UNITED STATES PATENT AND TRADEMARK OFFICE

APPLICATION NO.	FILING DATE	FIRST NAMED INVENTOR	ATTORNEY DOCKET NO.	CONFIRMATION NO.
10/721,168	11/26/2003	Pat A. Bolen	115584-00343	5533

Office Action Summary	Application No. 10/721,168	Applicant(s) BOLEN ET AL.	
	Examiner James R. Harvey	Art Unit 2833

DETAILED ACTION

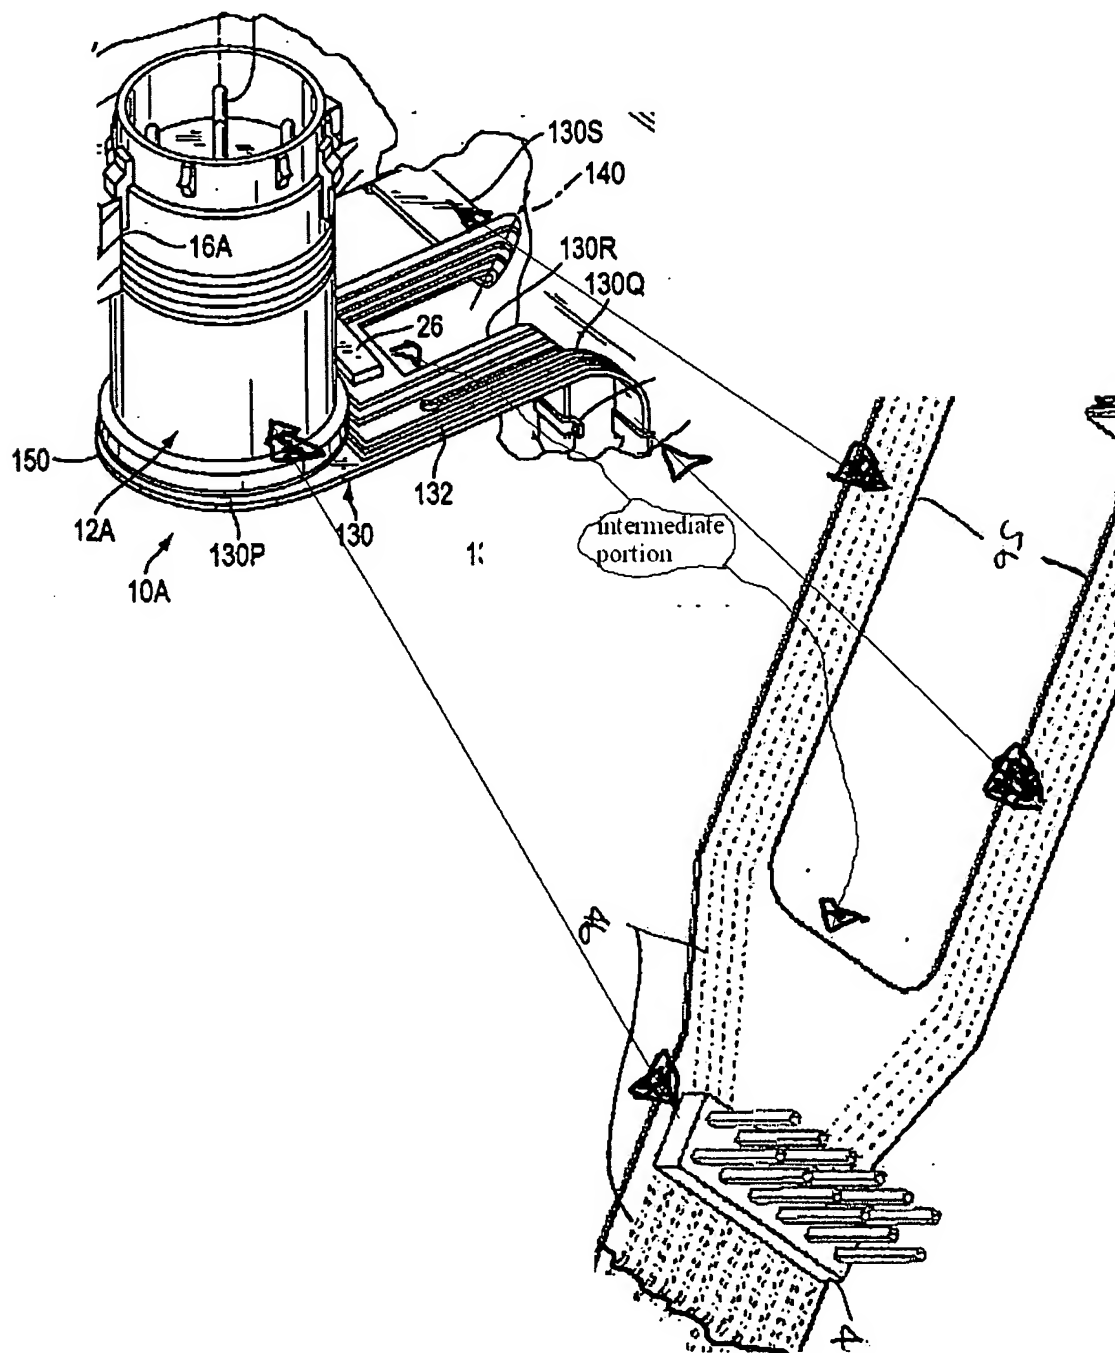
Muzslay shows (figure 10) substantially the same structure as that recited in claims 5 and 9 (see examiner's figure), Muzslay shows the mounting header 12A is located on an intermediate portion (figure 10; (between the two extreme portions (near the lead line of numerals 130S and 130Q ; (see attached definition from The American Heritage Dictionary))) of the flat cable 130, and the flat cable 130 further includes two extensions (130S, 130Q) having connectors (column 5, lines 20-23) on the ends thereof .
